## **ALERT SERVICE BULLETIN**

**412CF-24-77**

**SUBJECT:** CAP ANGLE, P/N 212-030-191-001, INSPECTION INTERVAL, REDUCTION OF.

**HELICOPTERS AFFECTED:** Serial numbers 46400 through 46999.

**Figure1. Fuselage Tailboom Attachment Inspection.**

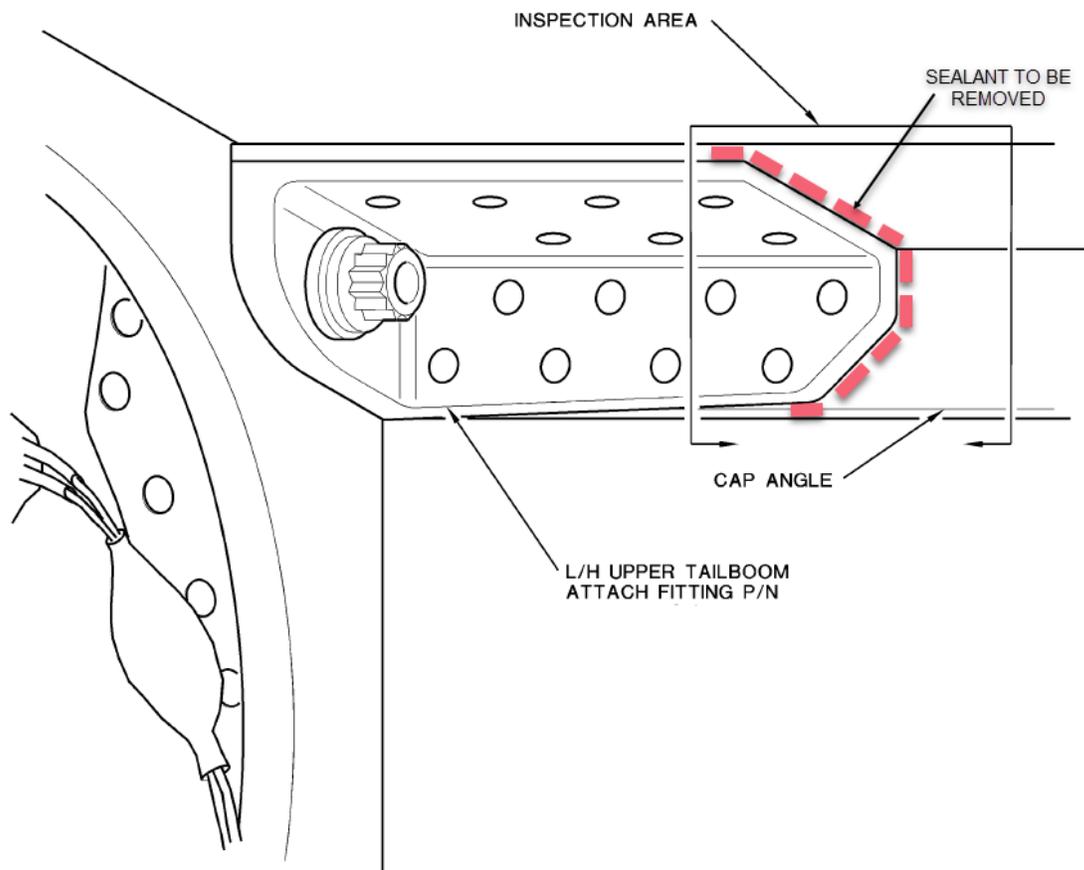
2. If sealant is present, remove sealant from edge of fitting (Figure 1).
3. Inspect the cap angle area shown with a 10x magnifying glass and bright light.
4. If a crack is found, replace the cap angle before further flight. If the helicopter is at a location where the cap angle cannot be replaced, contact Product Support Engineering.
5. Touch up primer if damaged during sealant removal. Paint touch up is optional. Do not reapply sealant.
6. If no cracks are found, the helicopter can be returned to service.
7. Make an entry in the helicopter logbook and historical service records indicating findings and compliance with this Alert Service Bulletin.
